## Compliance Assessment Report for: CAR\_NRW0046792 – Amended

<b>Permit number</b>	EPR/BX9471IU	<b>Operator name</b>	Tata Steel UK Limited
----------------------	--------------	----------------------	-----------------------

<b>Site name</b>	Trostre Works
<b>Site address</b>	Trostre, Llanelli, Carmarthenshire, SA14 9SD
<b>Type of assessment</b>	Site inspection

*Image 1 – Location of flume leak*

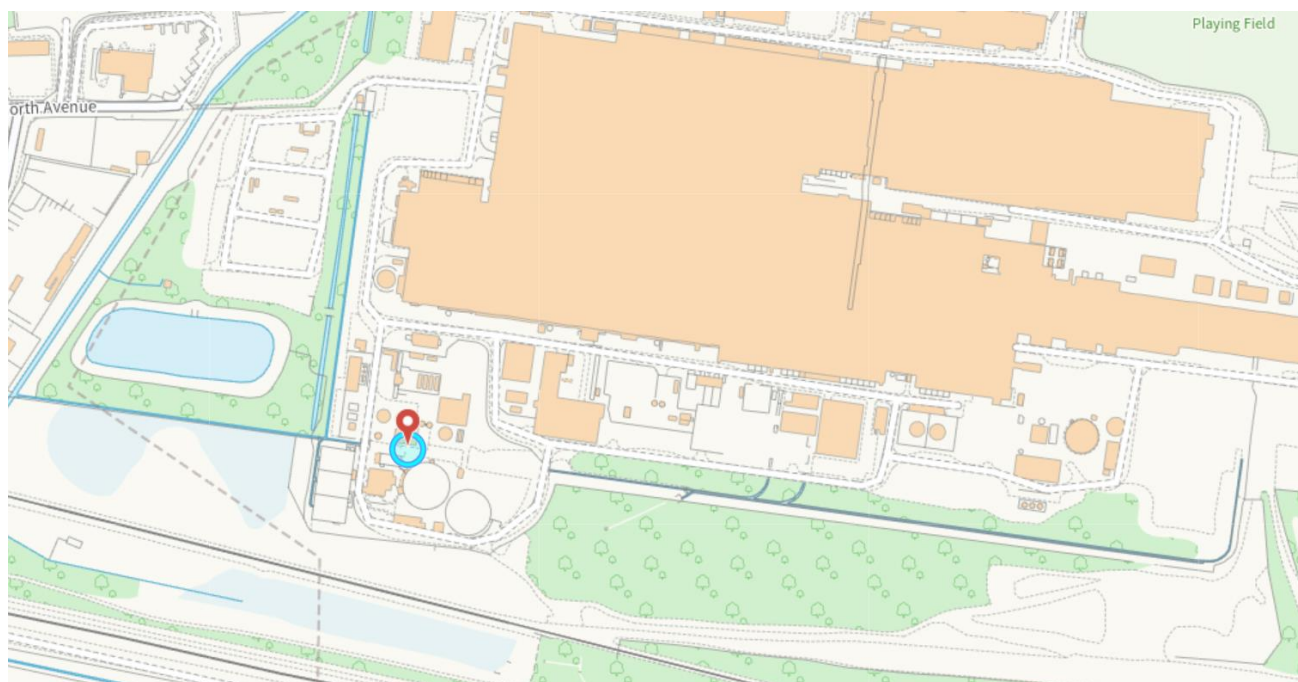
TSUK confirmed the incident was a result of a leak from the effluent flume which was detected on the 6<sup>th</sup> February 2025. The leak was located within the ETP area (made ground between the flume and clarifiers), national grid reference SS 52544 99186 as shown in *image 1*. The impacted section of the flume is of concrete and masonry brick construction with an internal fibreglass liner.

The leak was identified via an annual thermal drone survey carried out by a 3<sup>rd</sup> party specialist which identified an increase in ground temperature emanating from the flume flowing in the direction of the clarifiers; which are located within the southeastern corner of the ETP area. TSUK informed NRW that there was a delay in submitting the Schedule 5 Notification to NRW in order to facilitate a follow-up drone survey in order to confirm the presence of the leak.
